PROJECT: Villa's at Gardner Road
Village of Horseheads
Municipal Construction Inspection
March 28, 2019

BY: Jessica Verrigni, CPESC, CPSWQ

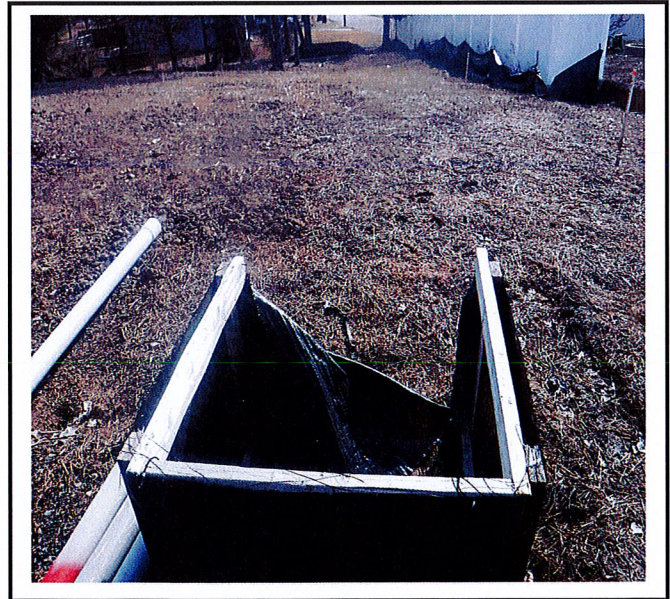
Major erosion from ditch into stormwater basin.

Rock outlet protection has not been installed.
